Zone A Pump Station and Transmission Main Project RFP Addendum #3

DATE ISSUED: 16 Feb 2023

The following changes, additions and/or deletions are hereby made a part of the Documents for the Construction of the PARADISE IRRIGATION DISTRICT ZONE A PUMP STATION AND TRANSMISSION MAIN PROJECT – JOB NUMBER 17-041 as fully and completely as if the same were fully set forth therein:

DESIGNED S. MAGLADRY	DRAWN B. TROTTER	CHECKED S. KADER	APPROVED S. KADER
PARADISE IRRIGATION DISTRICT ZONE A PUMP STATION AND TRANSMISSION MAIN PROJECT PARADISE, CA			
MECHANICAL FACILITY 20 PLAN			
DATE DECEMBER 2022			
PROJECT NUMBER 17-041			
DRAWING NUMBER 20-M-1			
SHEET NUMBER 26

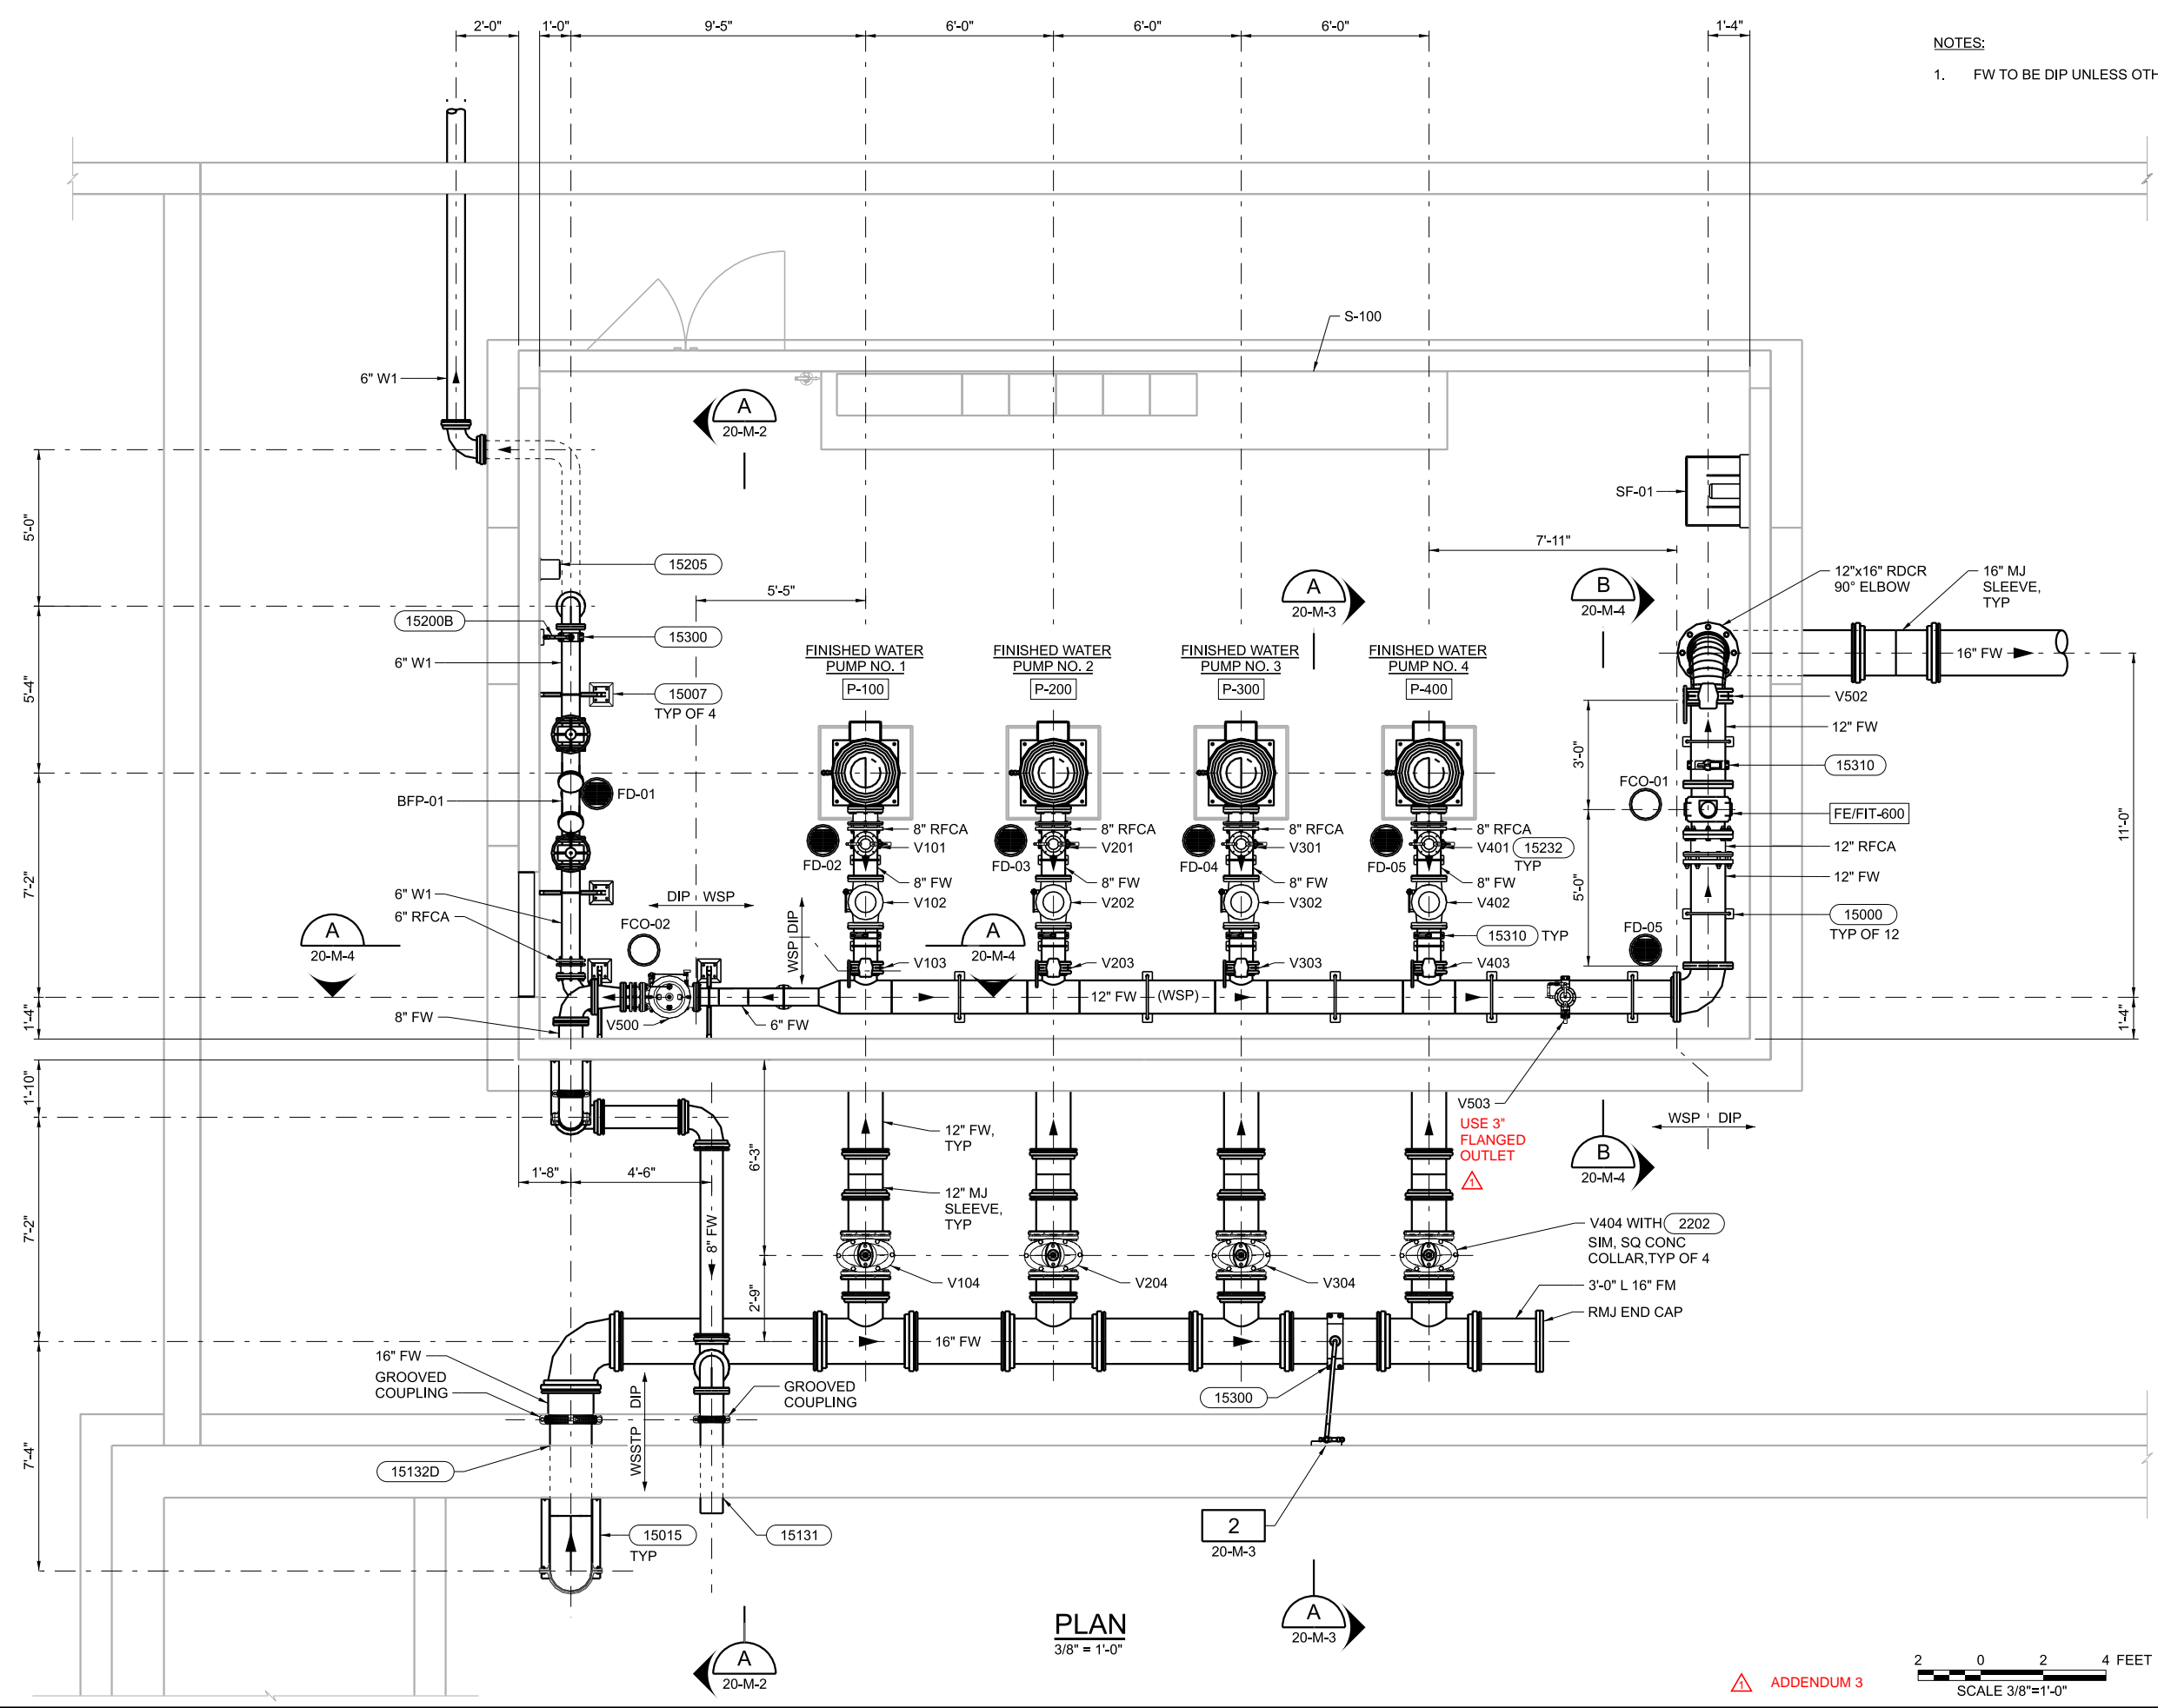
1. Provide **LUG** style valves per BFV-15. See Valve Schedule and Valve and Operators Specification revisions below.
 - e. On sheet 20-M-1 Facility 20 Plans, the combination air valve V503 is noted to reference detail 15234. Per the valve schedule this is a CARV-01 threaded 3” air valve. When I look at sheet SD-17 standard details 15234 it is calling for a 2” pipe coming from the process

pipe up to the combination air valve. This detail is also calling out for a backflush connection. In the specification section 15200 C CARV-01 combination air release valve for water service, section 2 c. calls for a single body type and section 3 manufacturers a. references a model 145C. This model is a single body water service combination air valve 2" and is not available with a backflush option. The details on the plans reference a sewage combination air release valve similar to an APCO model 401 with a backflush option. Do you want a water service single body air valve without a backflush option, or do you want a sewer combination air valve with a backflush option and is this to be a 3" per the valve schedule or a 2" per the detail and the referenced model number 145C?

1. See revised Valve Schedule V503. Provide CARV-02.
- f. Are insulating flange kits required at the connection between steel and ductile iron pipe per the "dissimilar metal piping connections" requirement of 15100.3.3.B.8.a(1)?

- d. **REMOVE** callout 15234 for V503 on Sheet 20-M-1. Add 3" flanged outlet to the WSP header for V503.

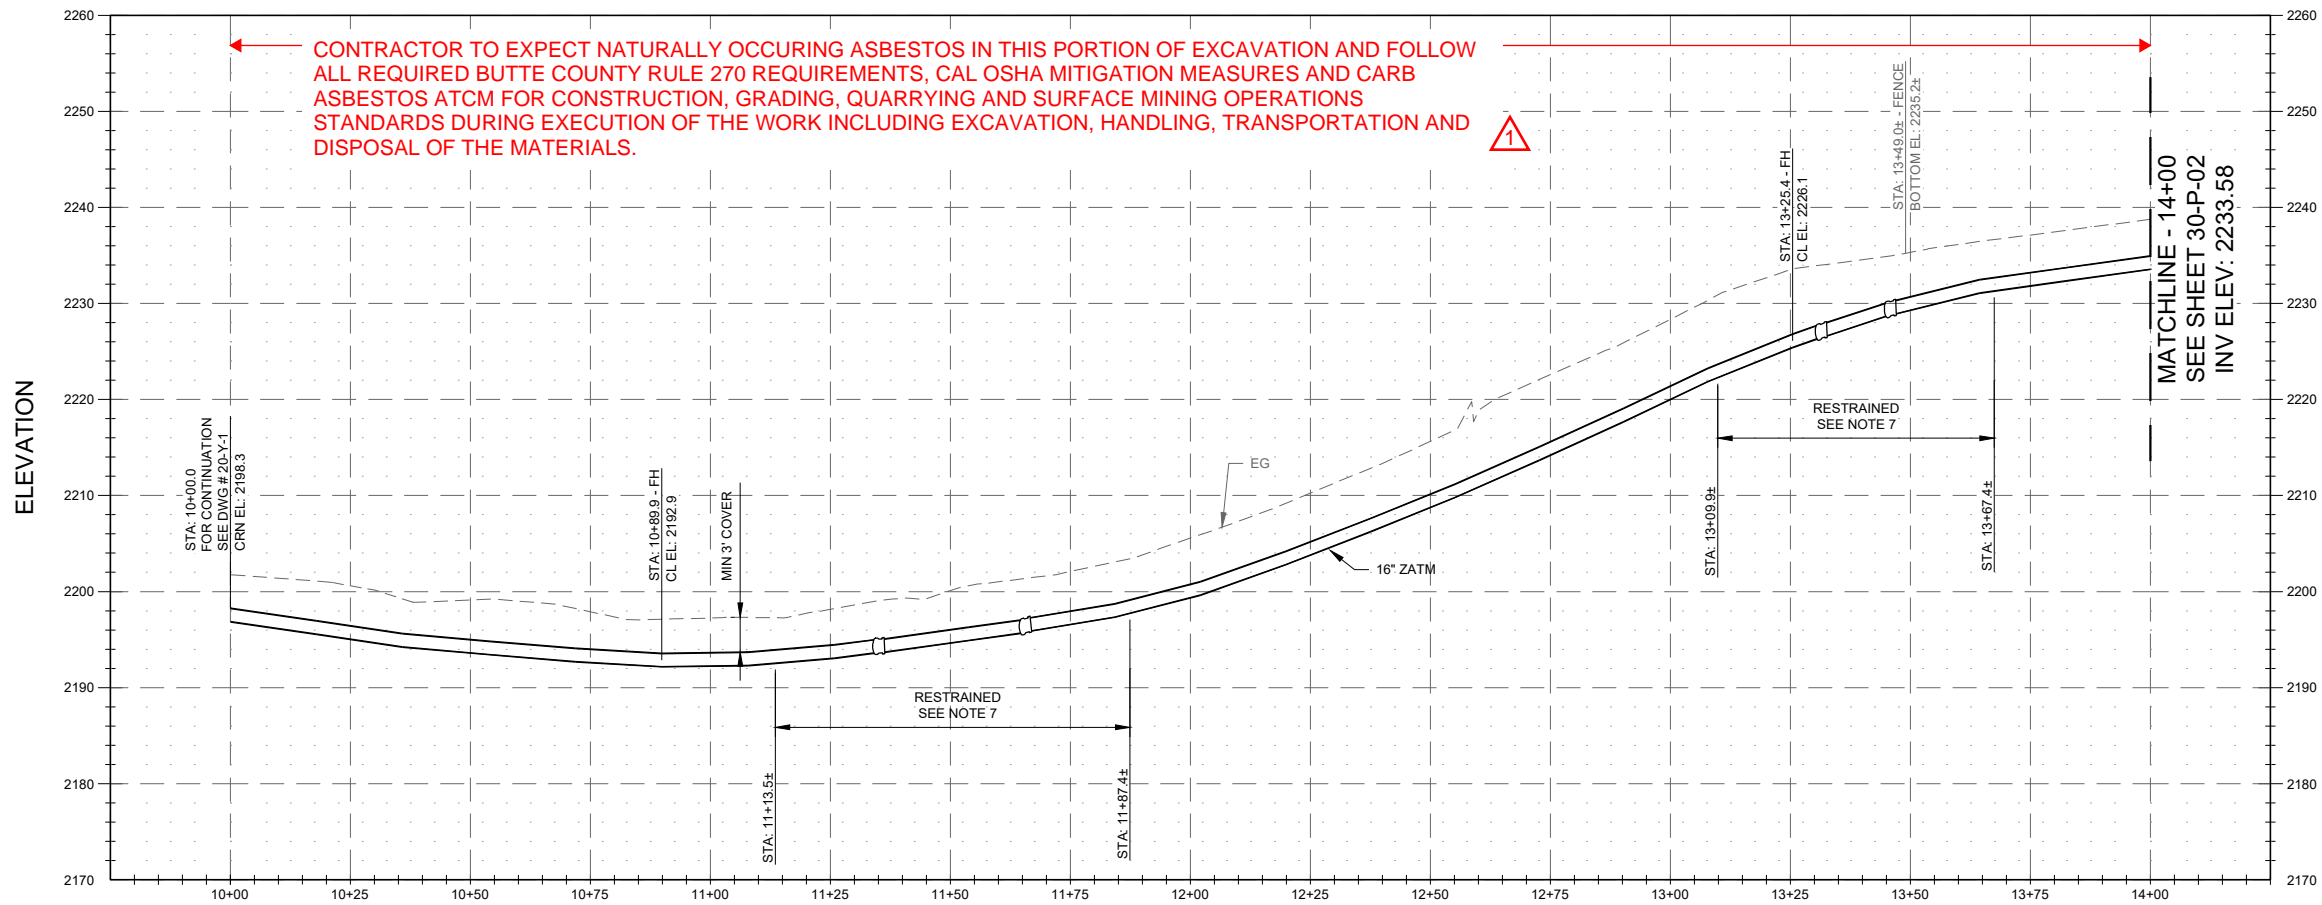
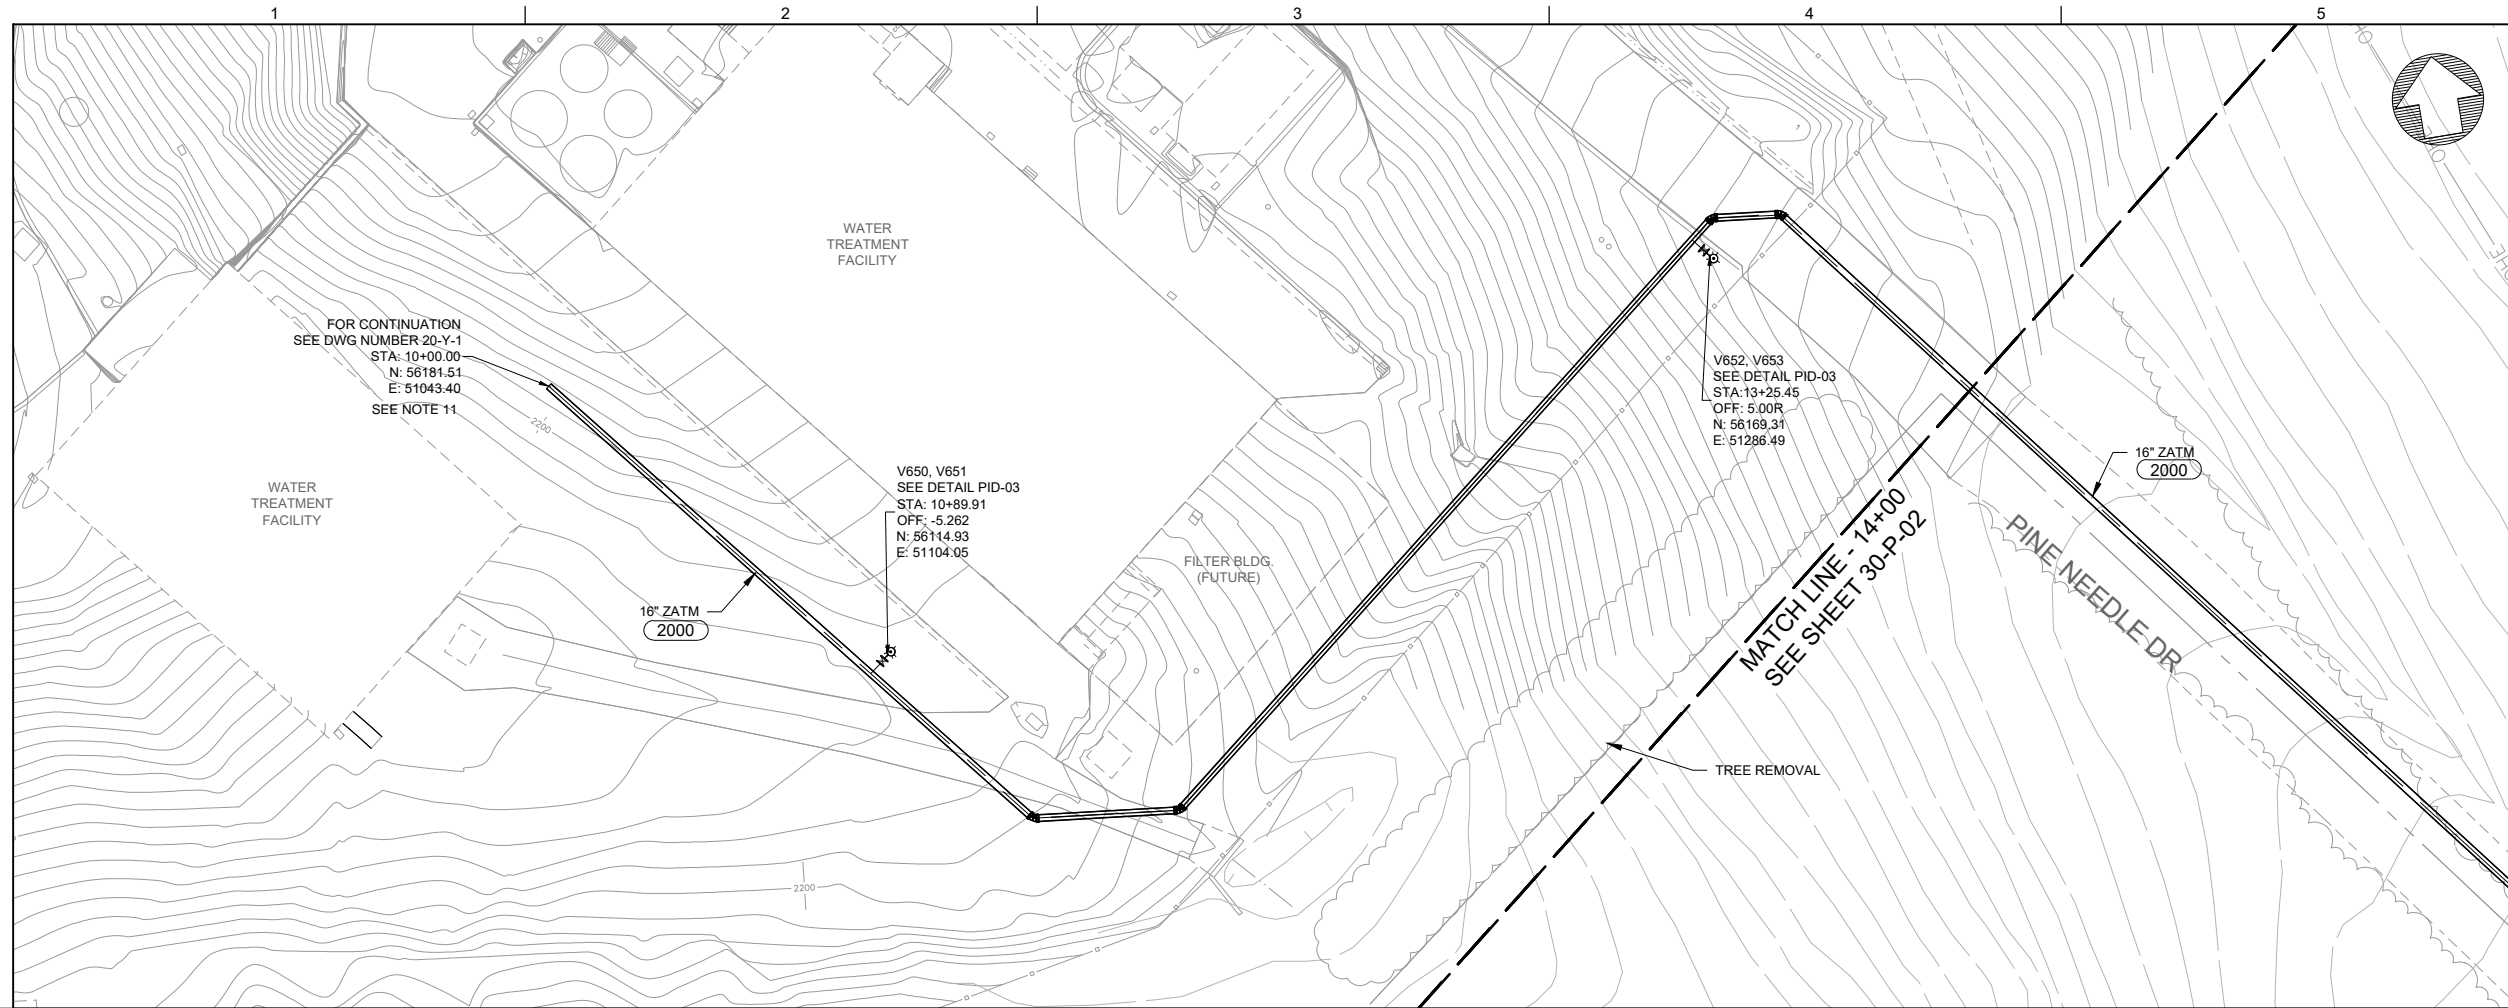
- bb. Page 46-62 note 1. states "Cover for buried pipe is 3' min. Unless otherwise noted. Replace trench backfill material with CLSM if buried pipe cover is less than 3'." Can we get some clarification? This does not agree with the "Existing Paved Area" drawing. It leaves interpretation for the trench backfill.

1. Backfill for ZATM to be CLSM in all paved areas.
 2. Backfill for ZATM in non-paved areas where cover is less than 3'0" shall be CLSM.
- cc. (continued from previous question) Does this mean if you have more than 3' of cover over the top of pipe you can use a 12" sand envelope over the top of pipe and a class 2 aggregate R.C. to 95% to RIM?
